ADDENDUM NO. 1

TUMALO RD / TUMALO PL INTERSECTION IMPROVEMENT

The Bidding Documents for the Tumalo Rd / Tumalo PI Intersection Improvement project are amended as follows:

TYPICAL SECTIONS

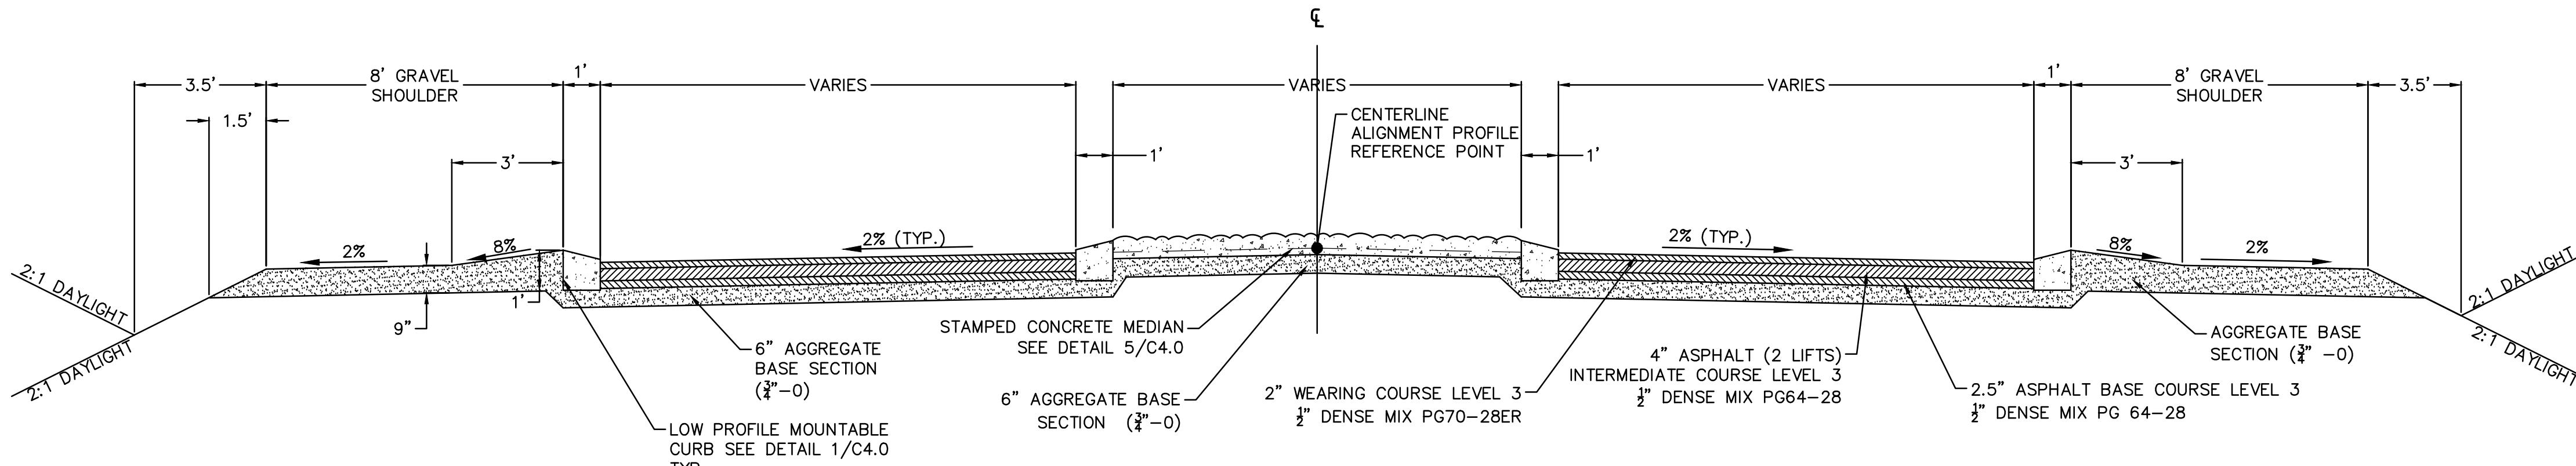
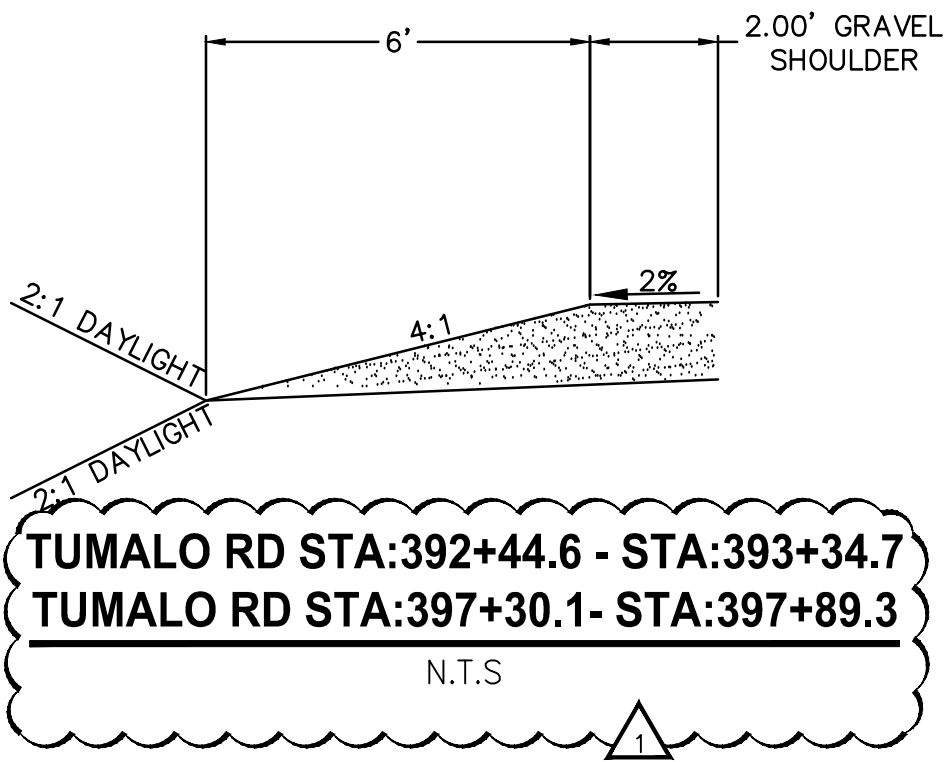
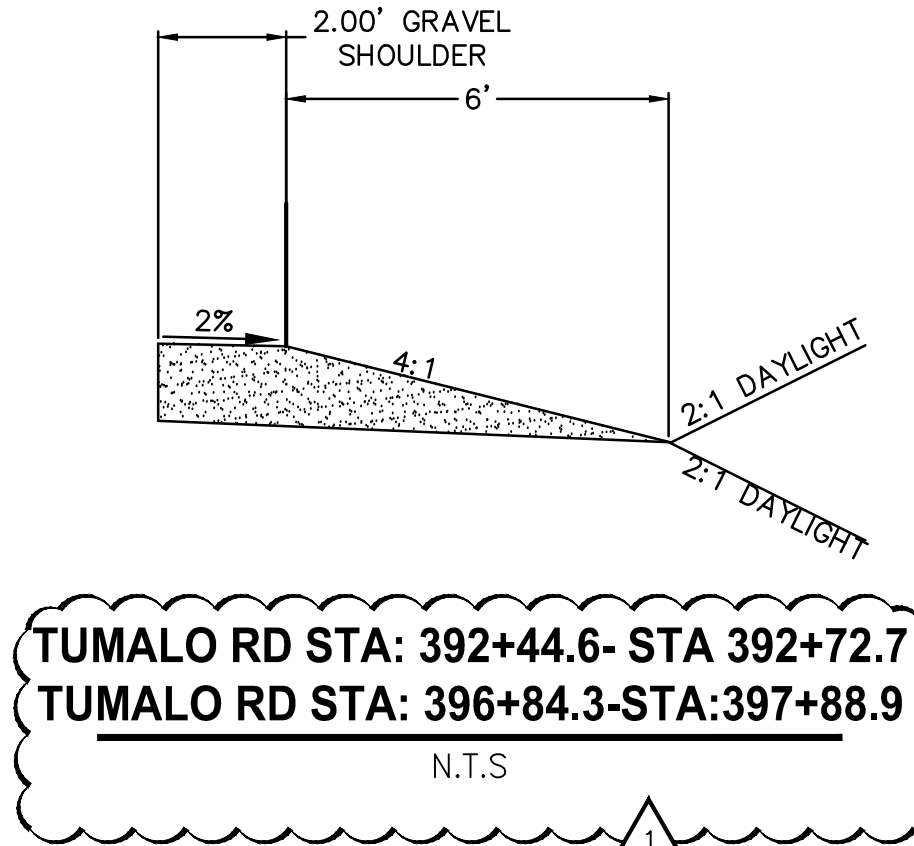
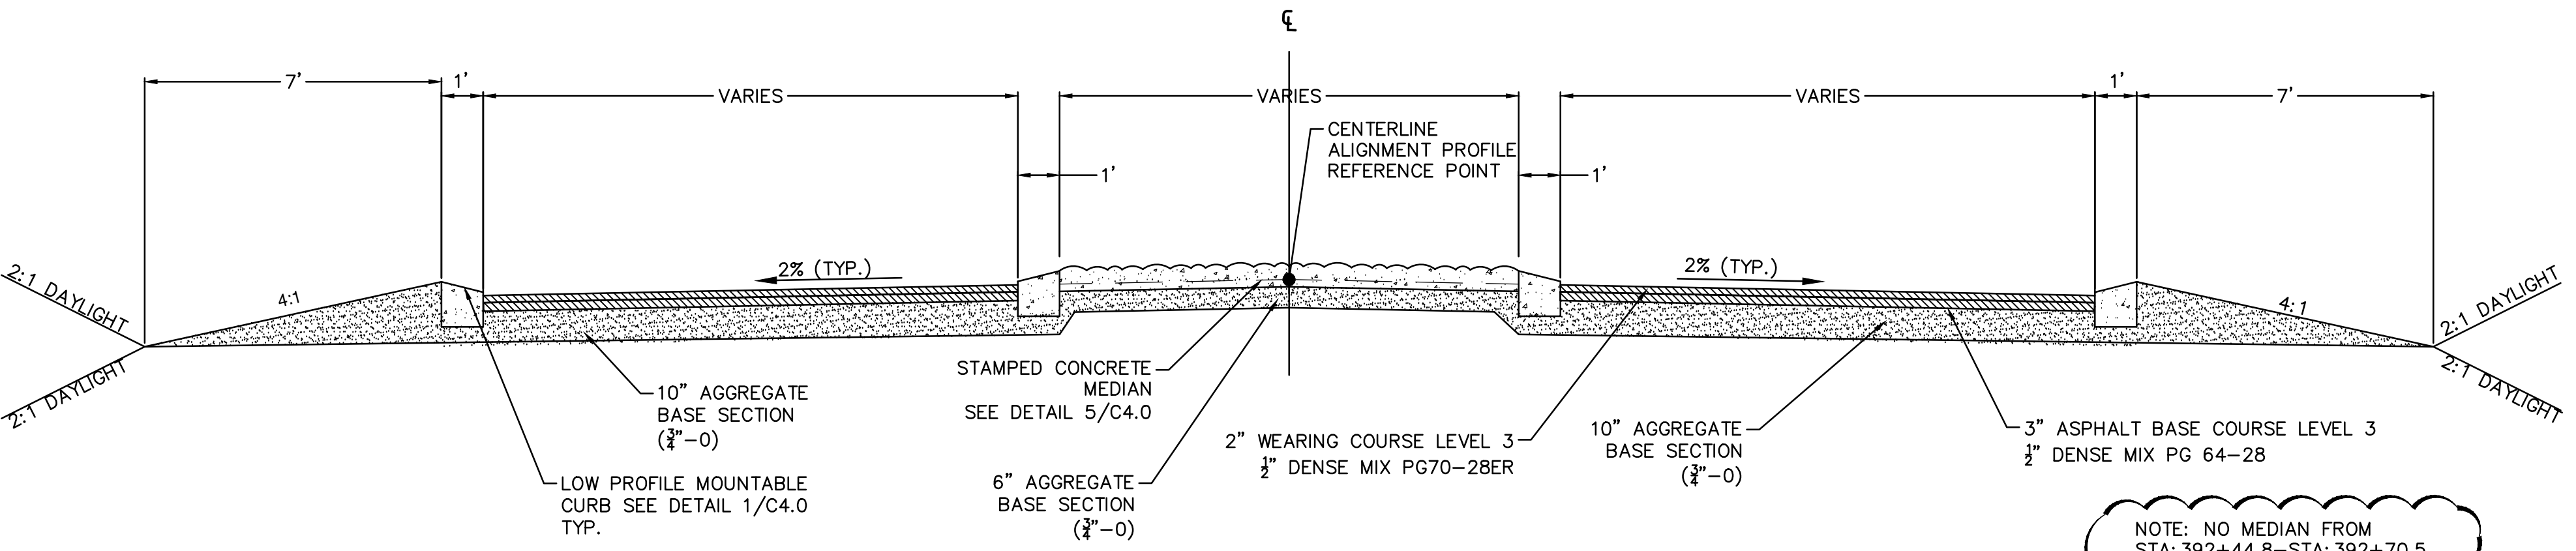
REVISIONS	DATE	BY	DESIGNED
1	9/22/20	DR	
TYPICAL SECTION STATIONING

TYPICAL SECTIONS

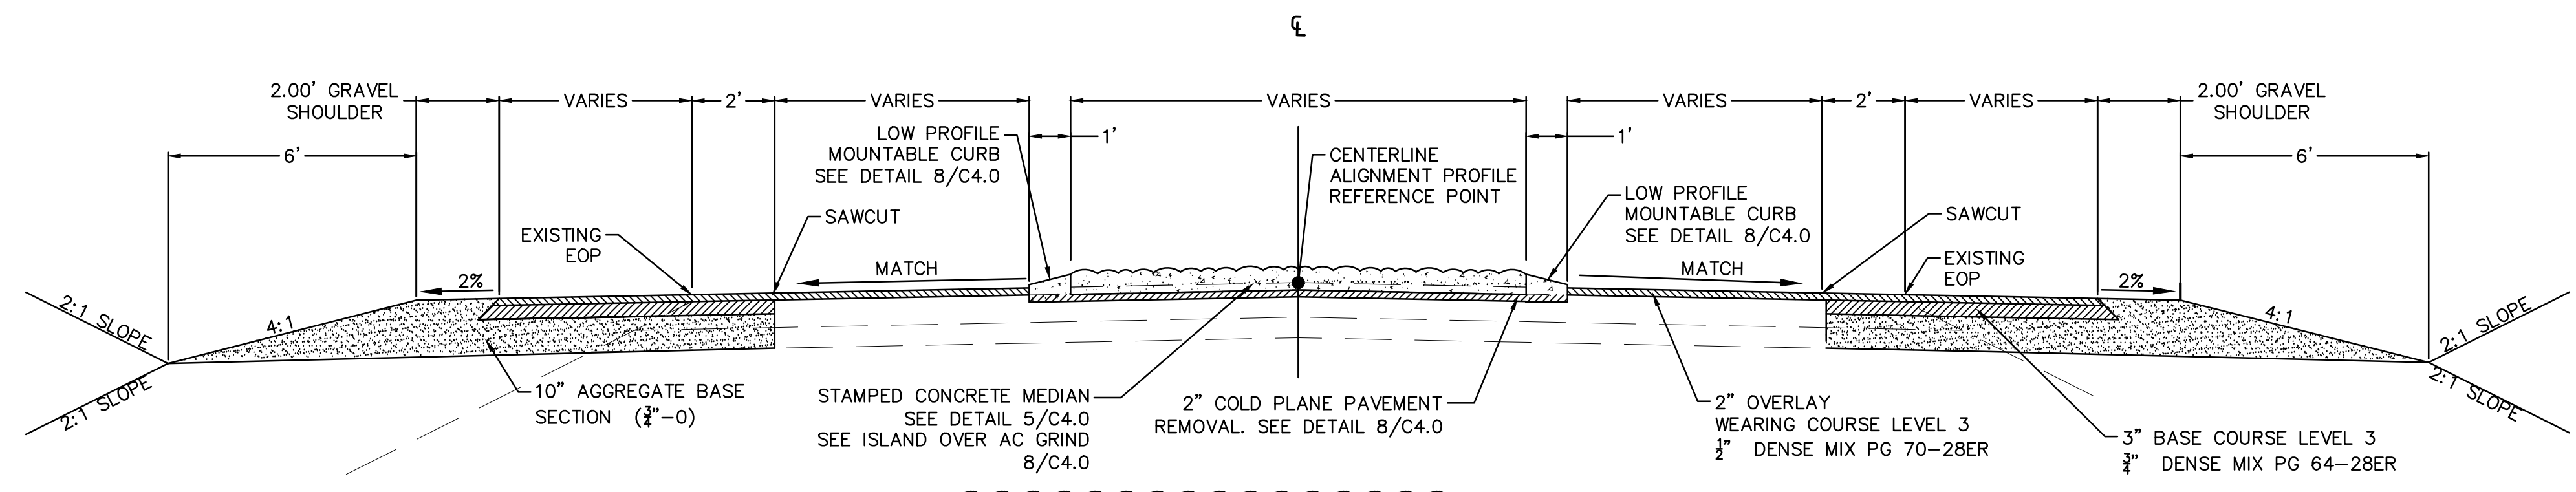
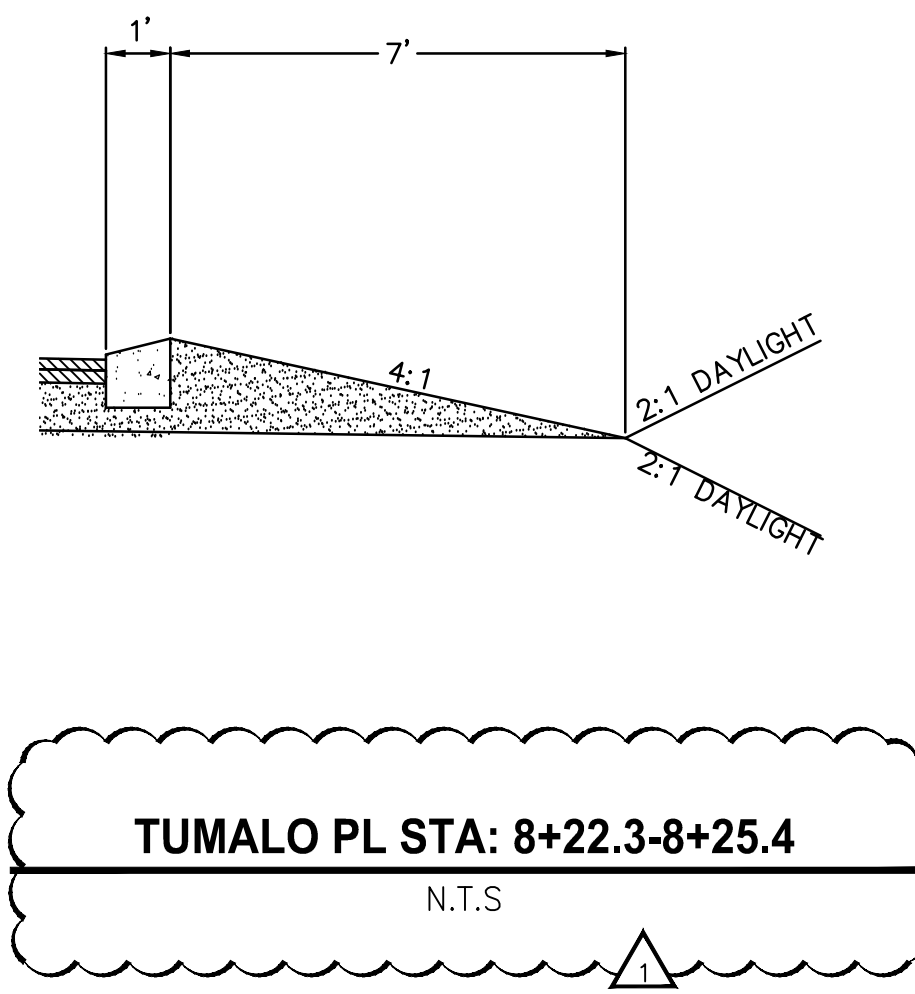
REVISIONS	DATE	BY	DESIGNED
1	9/22/20	DR	
TYPICAL SECTION STATIONING
